# PROCESS CHANGE NOTIFICATION

## PCN0902

### ADDITIONAL ASSEMBLY SOURCE AND BILL OF MATERIAL CHANGE FOR ALTERA FLIP CHIP PRODUCTS

**Figure 1. Date-Code Marking**

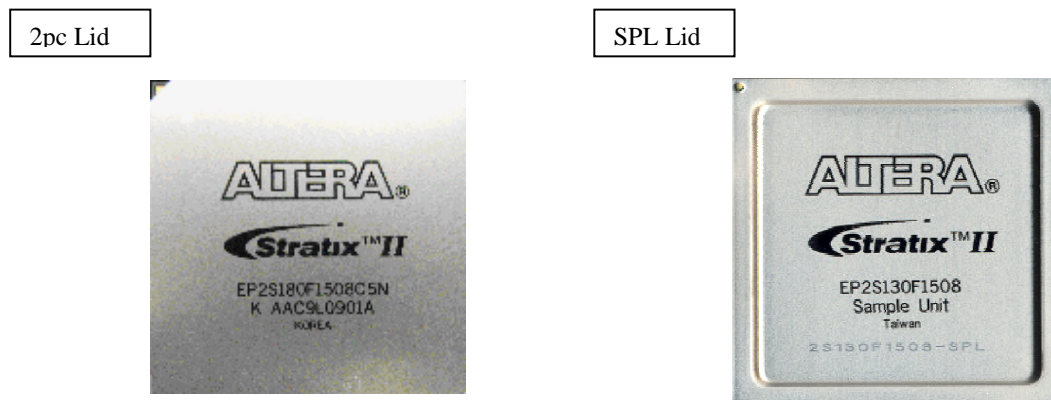
This change will be implemented in July 2009. Customers may receive products with this change beginning with a date-code marking of 0925 or later on the top of the package. See Figure 1. The 0925 date-code marking indicates the earliest date that the new material may be used for any of the affected devices. However, initial samples may have an earlier date-code marking.
